27 October 2009

10-8328 Independent Review AQ Bayswater B FINAL 20091027.doc

Independent Expert Review Bayswater B Power Station Expansion Air Quality Impact Assessment

Figure 1 Location of Redbank Power Station in Relation to R10 (Jerry’s Plains) and Bayswater & Liddell Power Stations

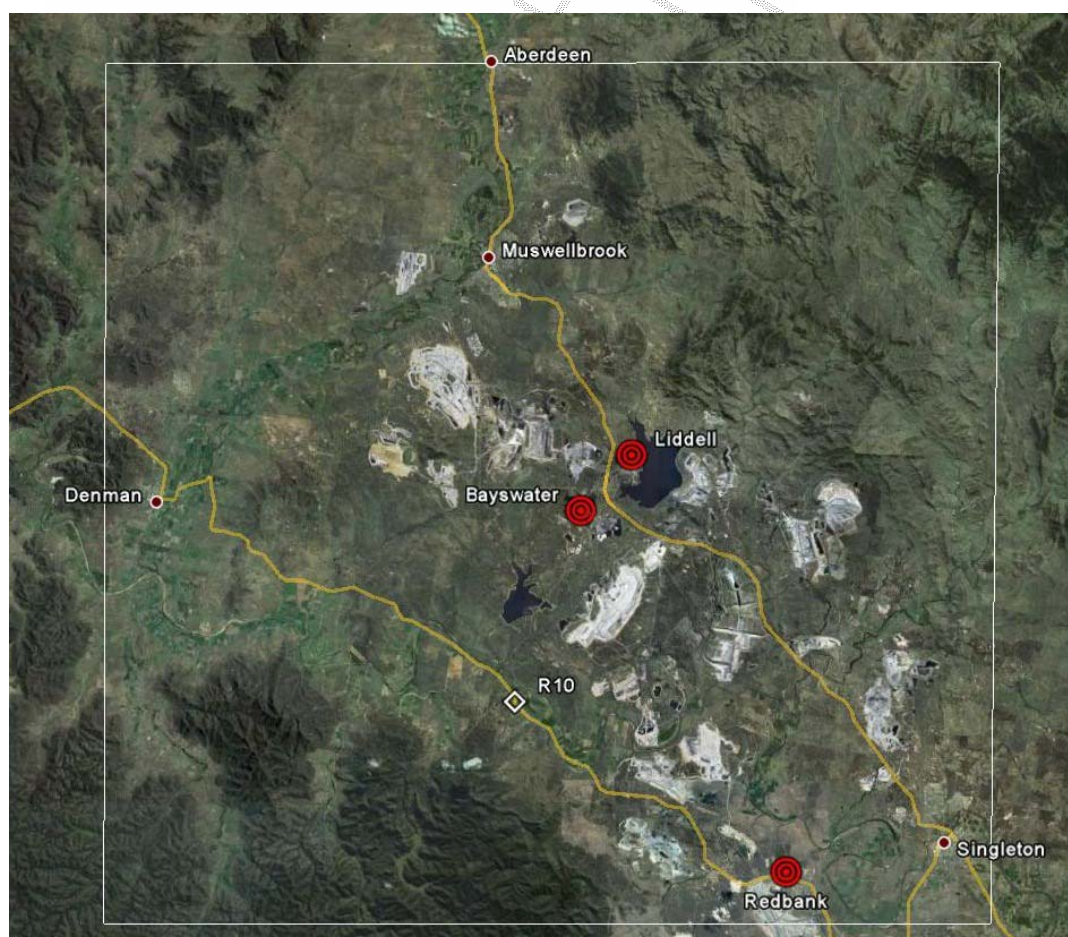
1. In the assessment of background HF, no assessment has been made of the contribution of Redbank Power Station, a 151 MW of coal fired capacity power station 22 km southeast of Bayswater (see Figure 1). Due to the significant proportion of south-easterly winds, it is considered that this source may have the potential to impact upon receptors within the modelling domain. It is acknowledged that the receptor of most significance for HF impacts is R10 which is not in alignment with Redbank and Bayswater / Liddell. However, for the sake of completeness it is recommended that this source be included in the assessment of all pollutants.

1. It is considered that a more robust approach to the assessment of cumulative impacts would involve the following scenarios:

- An existing operations scenario, incorporating emissions from the major SO₂ and NO₂ and HF sources in the local region – at minimum Bayswater, Liddell and Redbank power stations.
- Future operation scenarios, including emission sources incorporated within the previous scenario.
